TOWN OF WINTER PARK PLANNING COMMISSION Tuesday, January 23, 2024 8:00 AM

a. PUBLIC HEARING: Major Site Plan – Lions Gate Condominiums – 365 Lions Gate Drive (PLN22-078)

Minor Site Plan – 23 Maple Road – Amended Lot 4, Block 4, Winter Park Village Subdivision

RE PUBLIC HEARING: Major Site Plan – Lions Gate Condominiums – 365

P550102-031-30

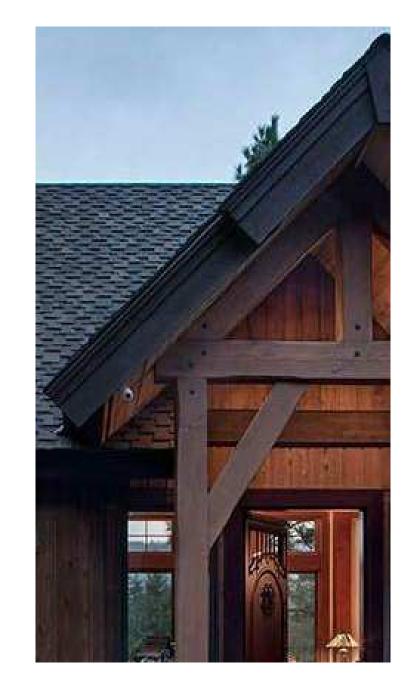
Unsatisfactory. One (1) fixture is proposed and does not contain the International Dark Sky Association (IDA) approval stamp (UDC, § 3-K-3(A)(1)). Single-family properties are limited to 5,100 lumens and each fixture shall not exceed 850 lumens. The overall site well exceeds the 5,100 limit at 11,466 lumens. Given there are decks with overhangs proposed, Applicant shall clarify if any outdoor soffit lighting is proposed.

- Applicant shall submit an outdoor lighting fixture approved by the IDA.
- Applicant shall update the Outdoor Lighting Tabulation on the Minor Site Plan Application Form to reflect this change.
- Applicant shall clarify if any outdoor soffit lighting is proposed.

SITE PLAN

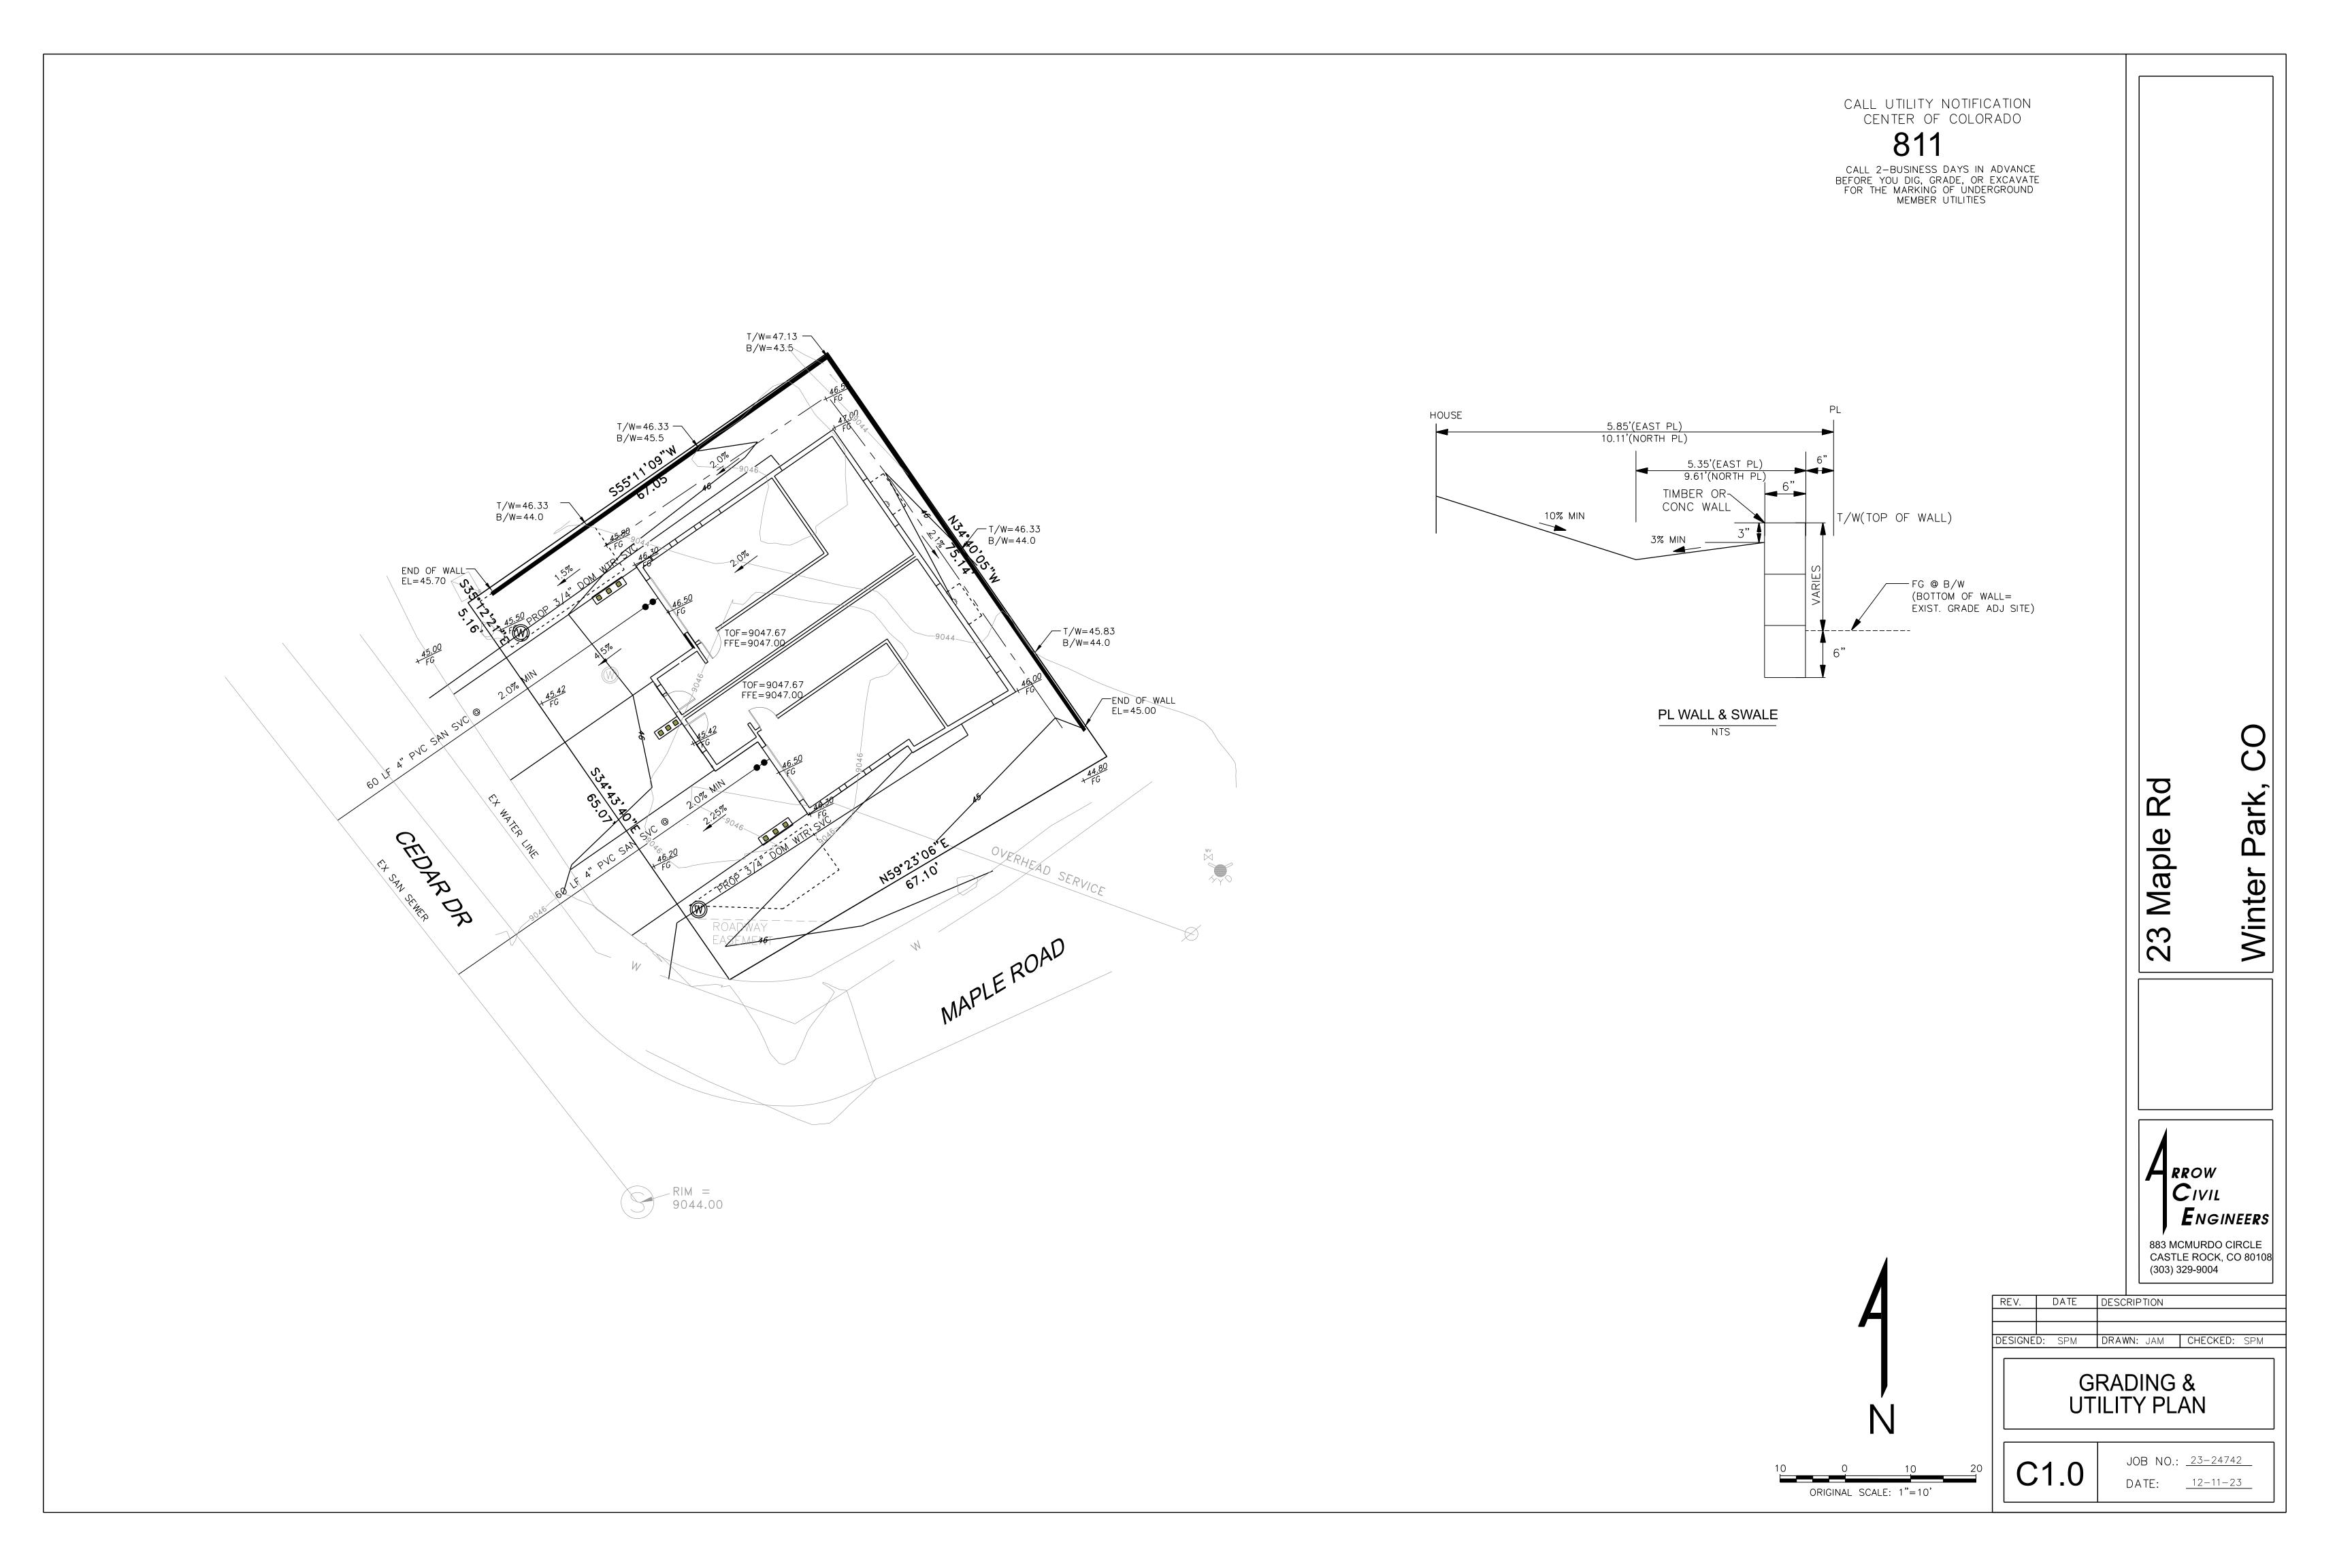
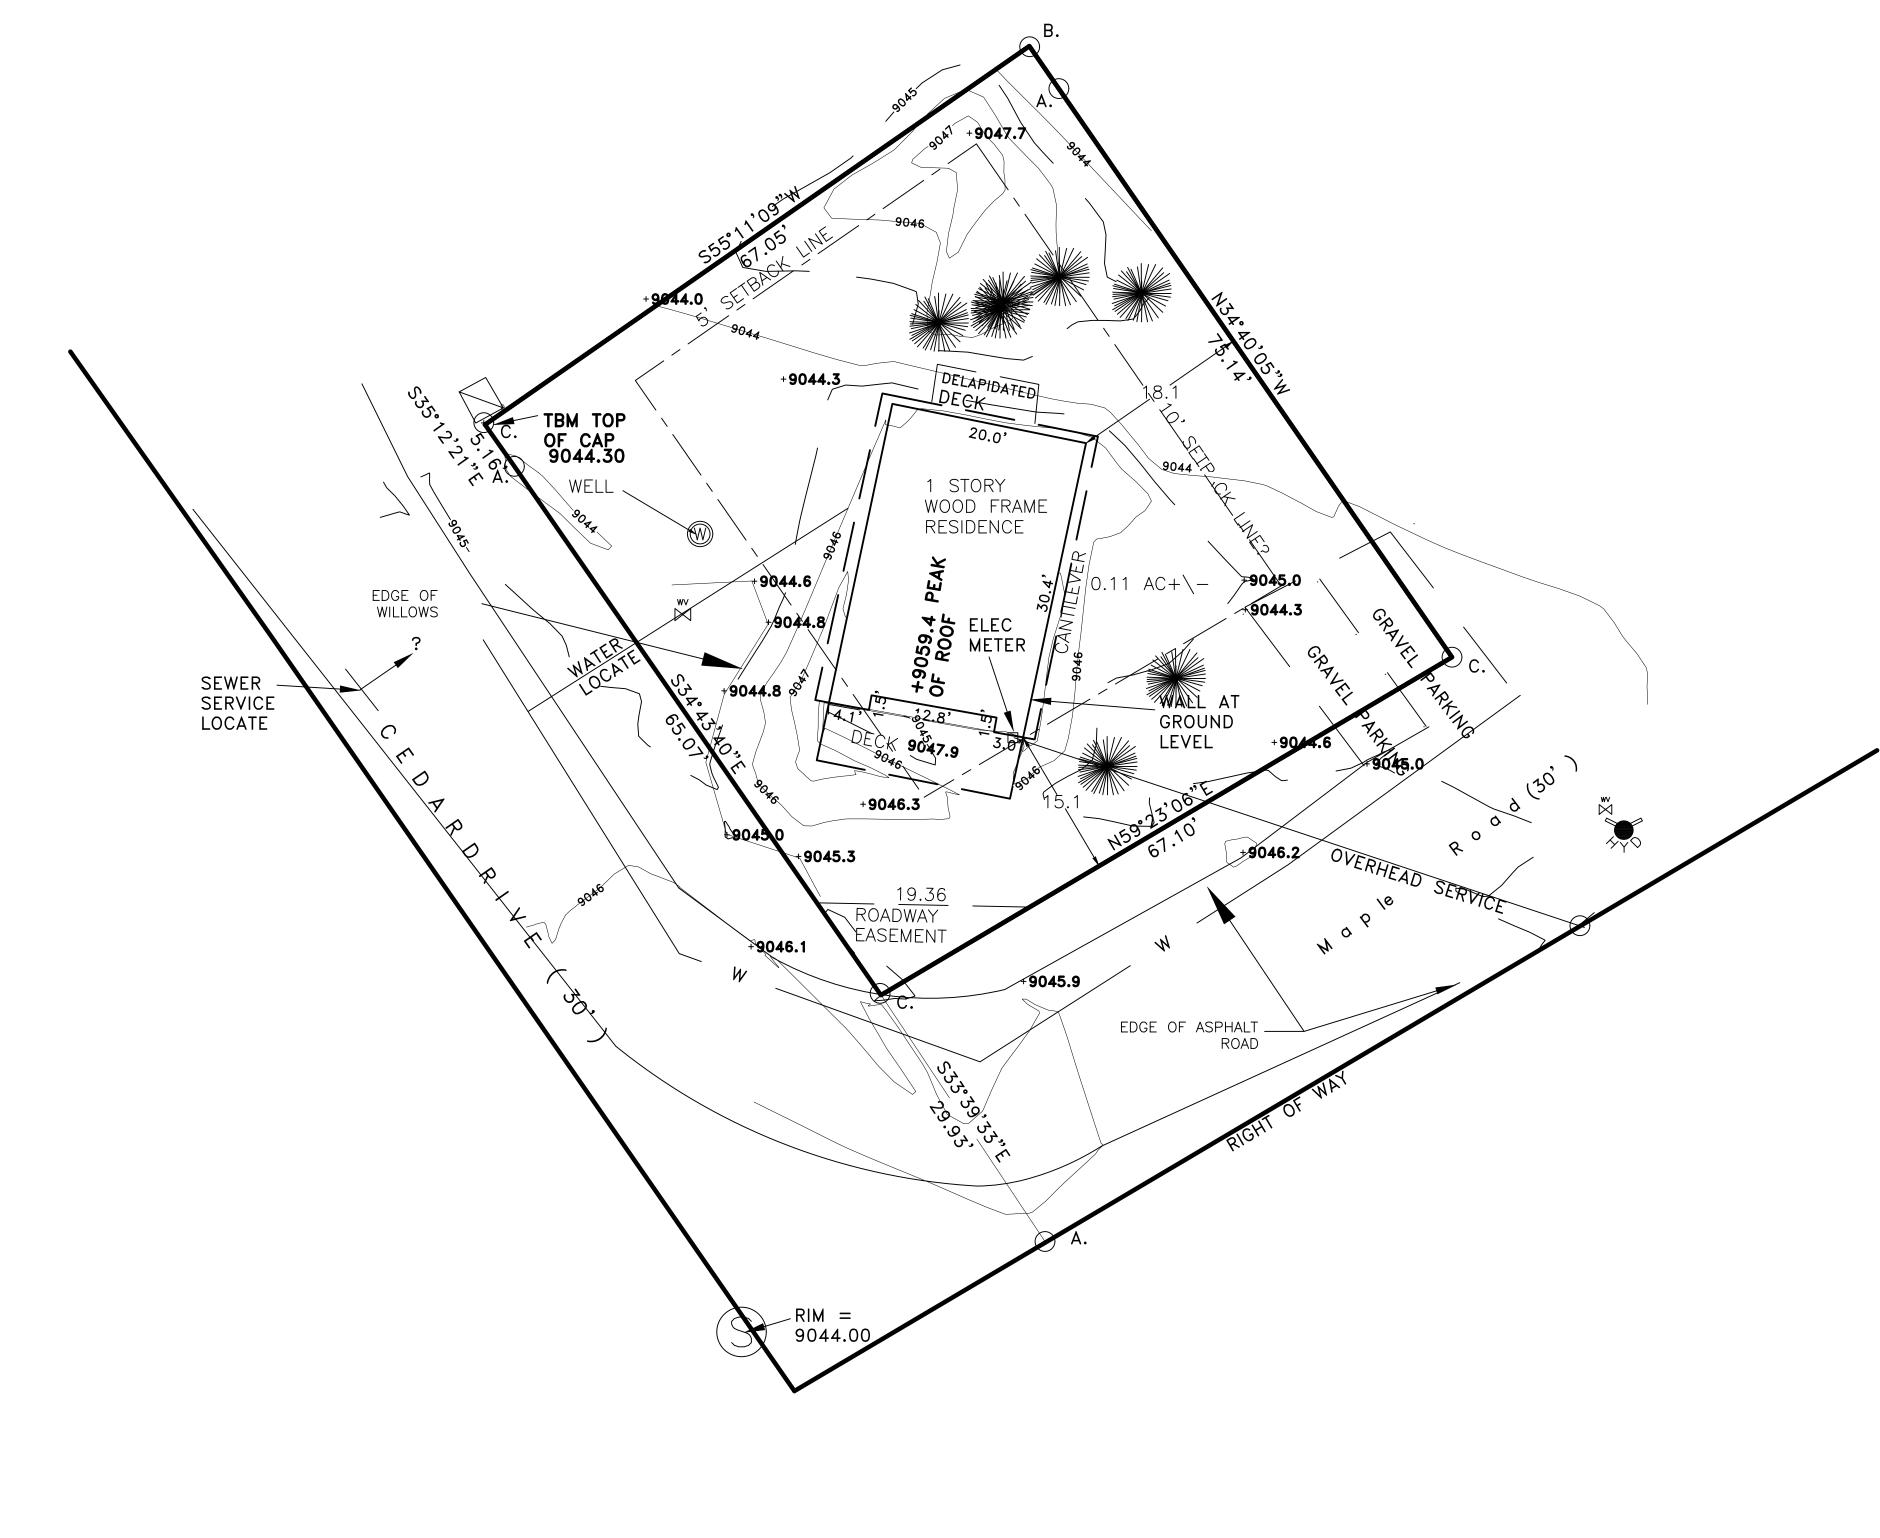
- Applicant shall indicate on Construction Plans the parking spaces for construction workers' vehicles
- Applicant shall indicate the existing 5' utility easement adjacent to the northeast lot line.

- The Site Plan shall be updated to show the driveways being paved and shall indicate the proposed material.
- > A stabilized construction entrance shall be installed prior to ground disturbance.

- 5. Applicant shall indicate on Construction Plans the parking spaces for construction workers' vehicles.
- 6. Applicant shall indicate the existing 5' utility easement adjacent to the northeast lot line.

LANDSCAPE PLAN

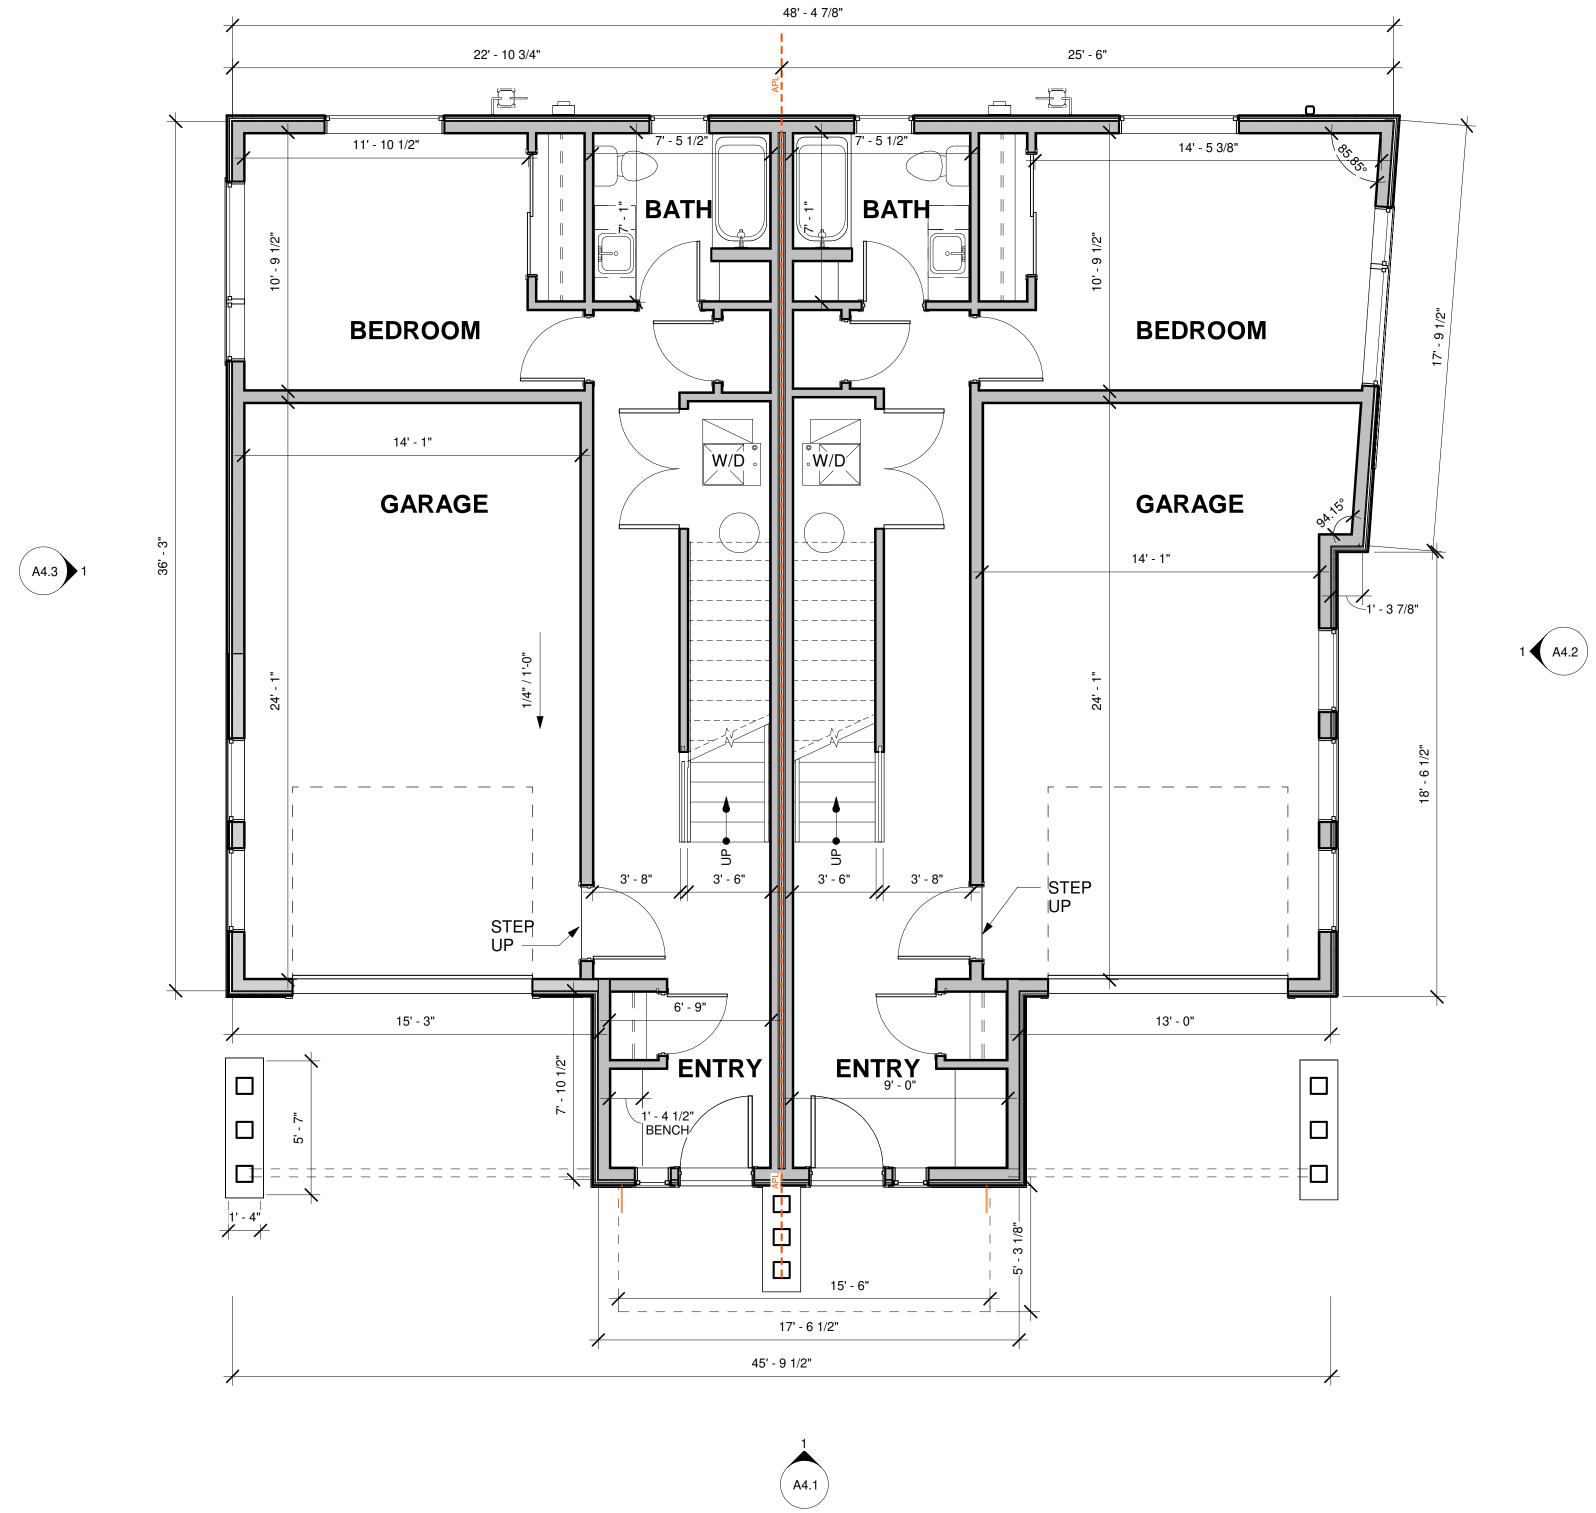
Partially satisfactory. Duplexes are required to provide only a Type A bufferyard as seen in footnote 1, Table 3-I-5-2, District Bufferyard Standards. There are three trees proposed within the existing 5' utility easement on the northeast lot line, which is prohibited.

- Applicant shall revise Landscaping Plan to remove any landscaping within the existing 5' utility easement.
- ➤ No site clearing shall be permitted until the Building Division has verified the Pre-Disturbance Inspection Requirements have been implemented on the Property.
- Any disturbed areas on the site shall be revegetated with the seed mix recommended by the Grand County Natural Resource Conservation Service, which mix composition is described in Section 7.4 of the Standards and Specifications for Design and Construction.

COLOR PERSPECTIVES

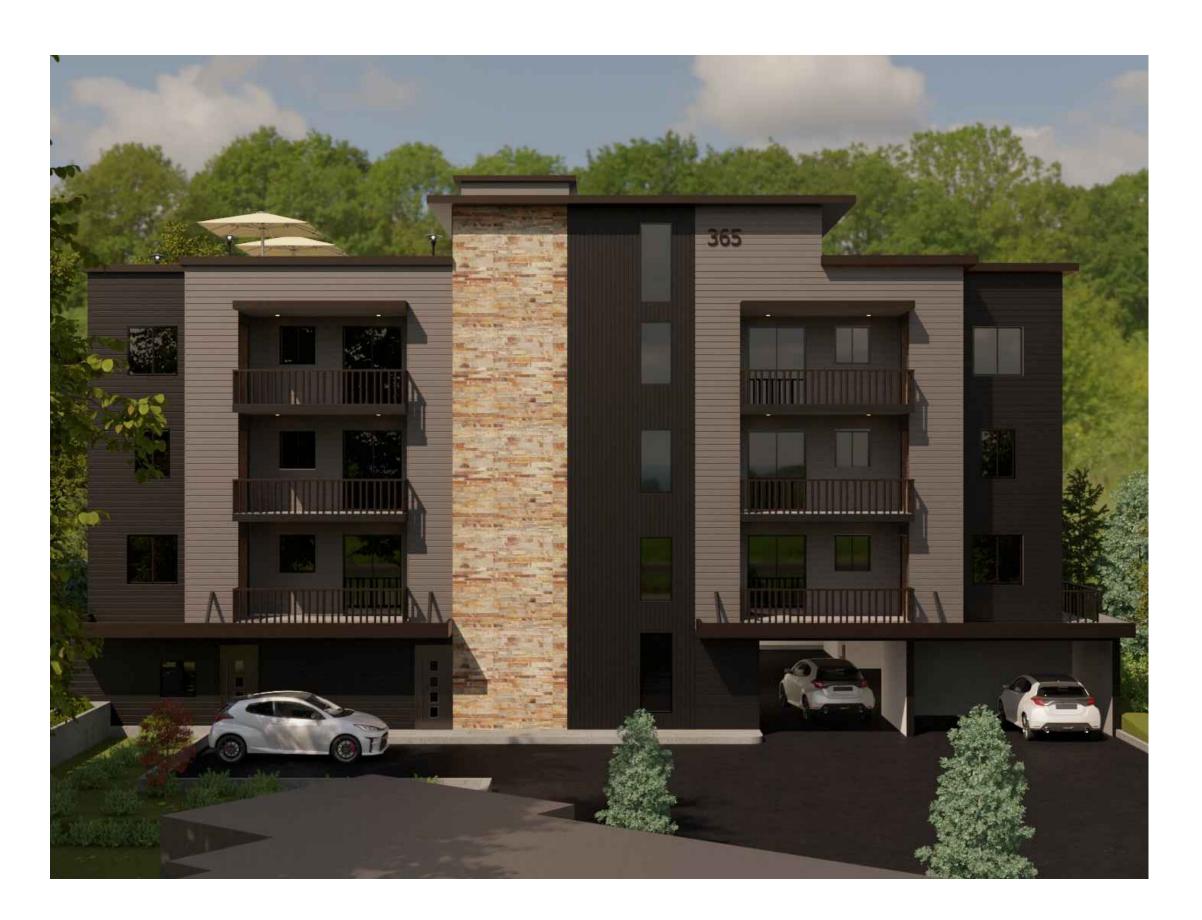
- * "NORTH ELEVATION" drawing on G3.1 does not match the direction of building with the "NORTH ELEVATION COLOR -NOT TO SCALE" on A4.1; will we be looking at decks or a wall with windows?
